RE: **Entertainment Facility**
3930 Pan-American NE
Grading and Drainage Plan
Engineers Stamp Date: 5/31/2018
Hydrology File: G16D145A

DRAINAGE AND TRANSPORTATION INFORMATION SHEET (REV 10/2015)

**RE: ENTERTAINMENT FACILITY
3930 PAN-AMERICAN NE
CONCEPTUAL GRADING AND DRIANAGE PLAN
ENGINEERS STAMP DATE: 5/3/18
HYDROLOGY FILE: G16D145A**

VOLUME CALCULATIONS
First Flush Pond

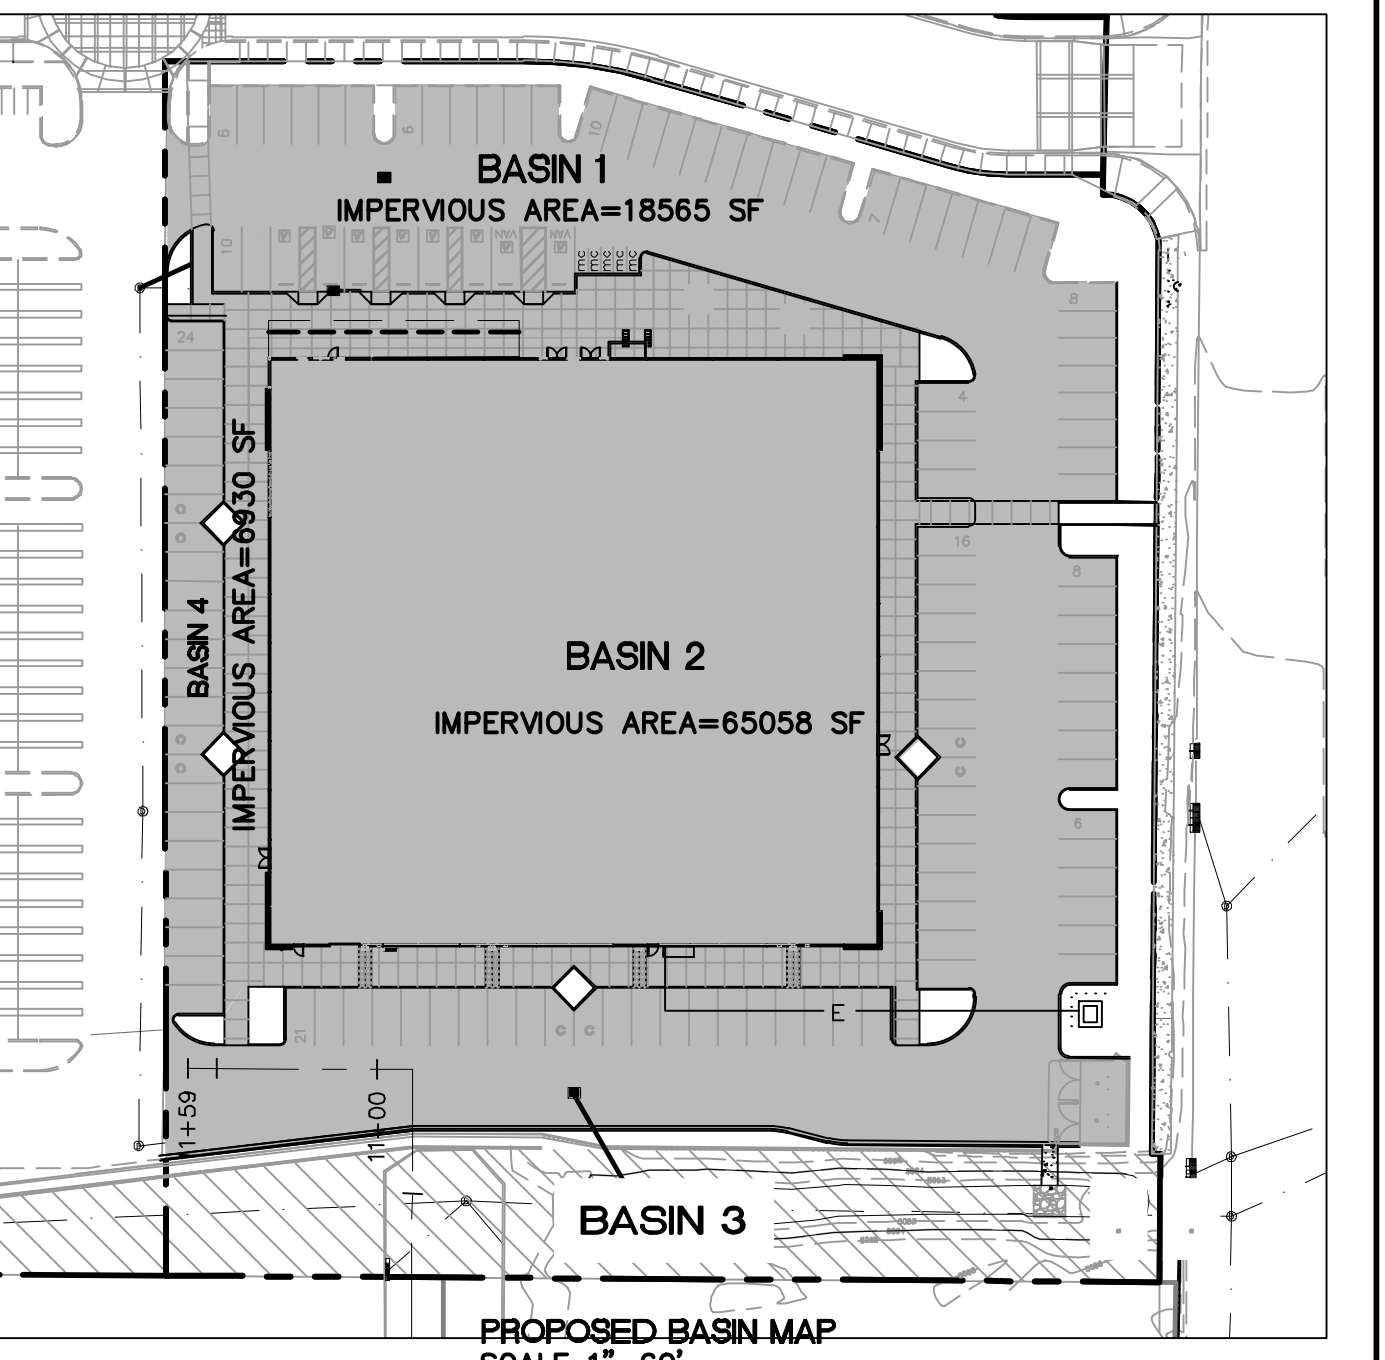
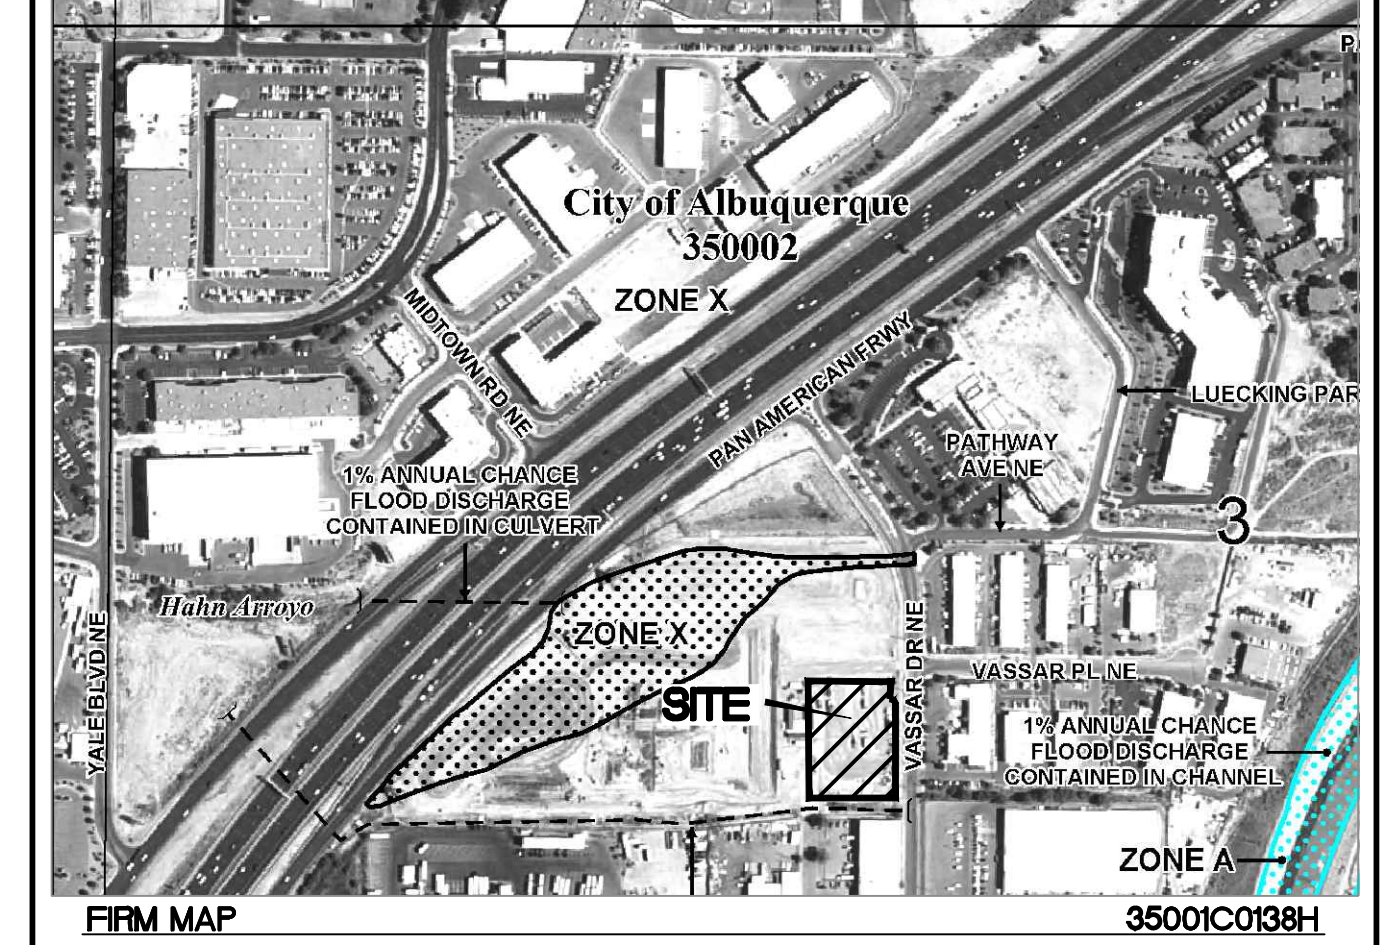
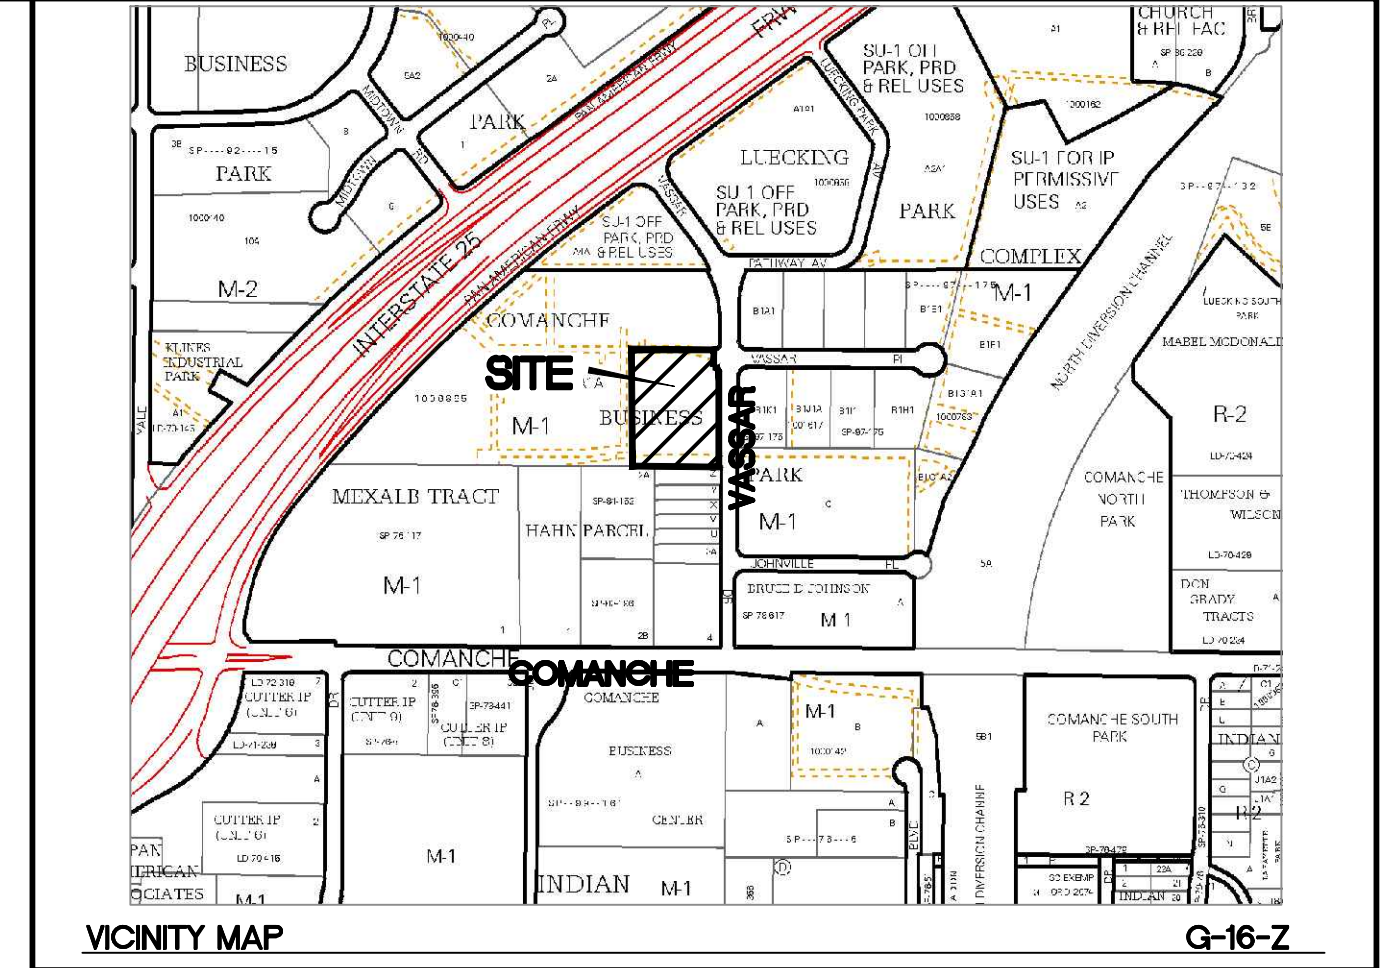
1. First Flush volume calculations are required for the volume provided by the onsite pond. They should be based on dimensioned details, so the slopes inside the pond should be labeled on Section AA and the proposed contours in the plan view should be located to agree with the slopes shown on the cross section. Labels are not legible on some of the contours.
Additional information was provided on the Grading Plan and the cross-sections. Dimensions were added and labeling cleaned up.

EXPANDED METAL INLET PROTECTION
N.T.S.

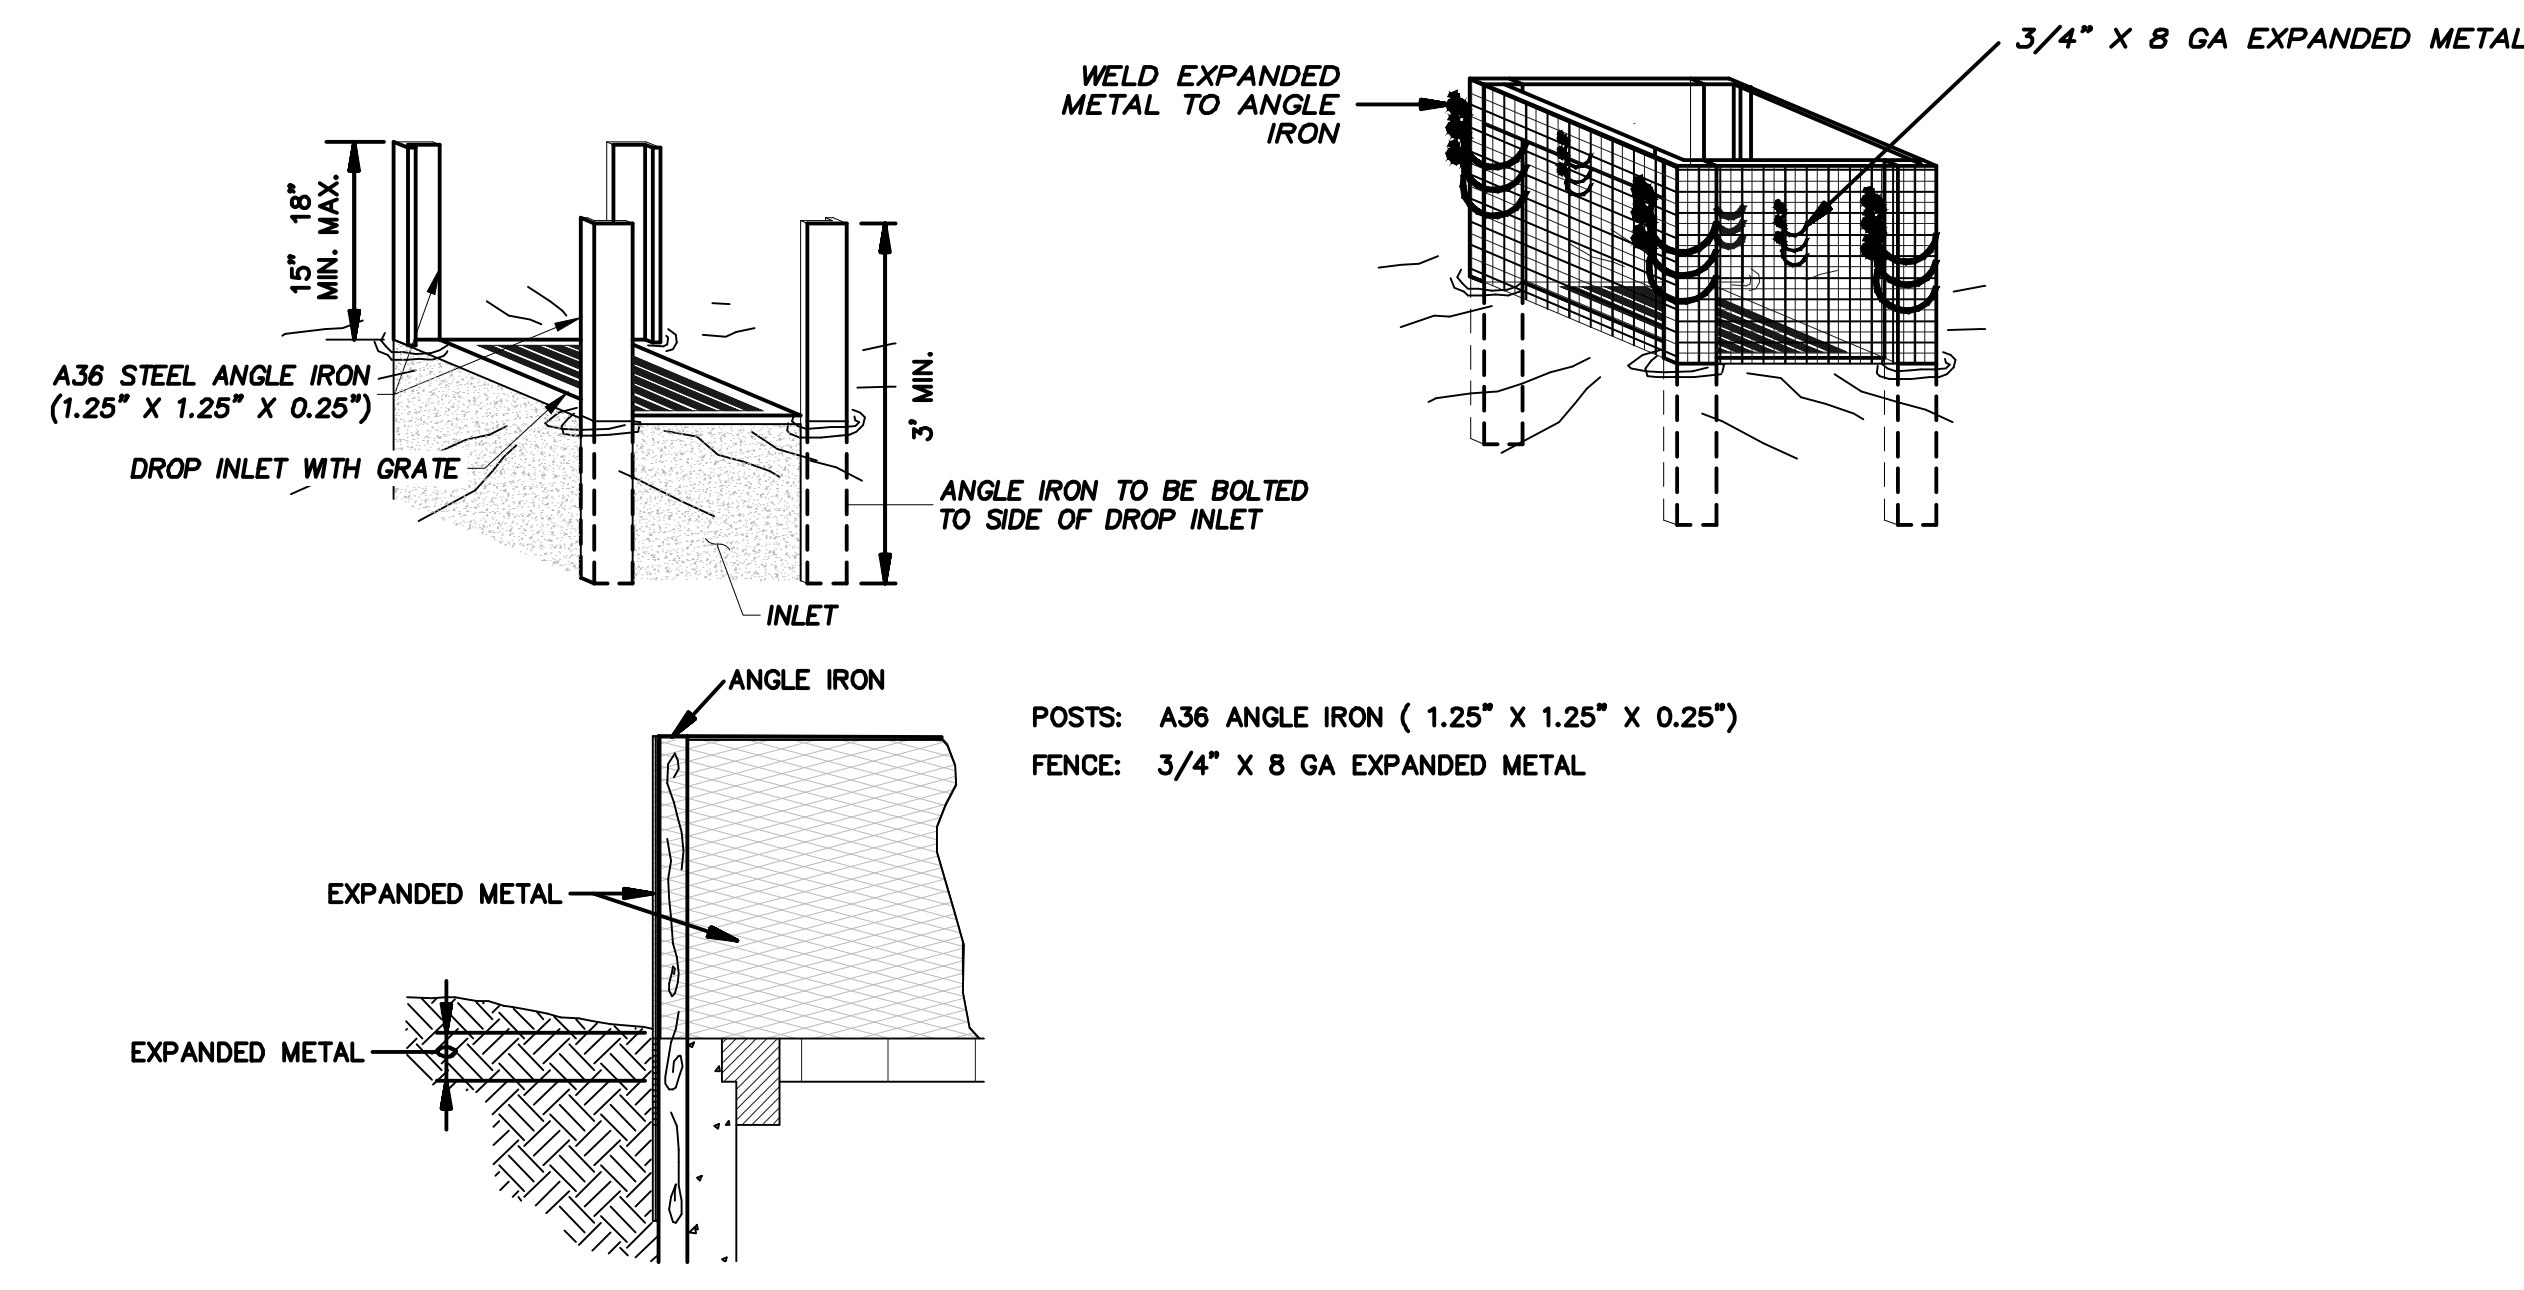
2. Details of the existing and proposed drainage structures in the onsite pond need to be added to the plan along with capacity calculations. A detail of the existing primary pond outfall structure must include construction specifications for modifications to prevent floatables from leaving the pond during the 100 year peak flow without clogging and calculations must be included demonstrating that the 100 year flow depth at the primary outlet will remain below the crest elevation of the existing concrete dam.
A second sheet was added to the set to detail a expanded metal barrier to be constructed around the existing inlet that would not allow floatables into the existing storm sewer system. The top of the grate will be at a higher elevation than the top of the existing concrete weir so that even during a large rain event no floatables will enter the inlet.
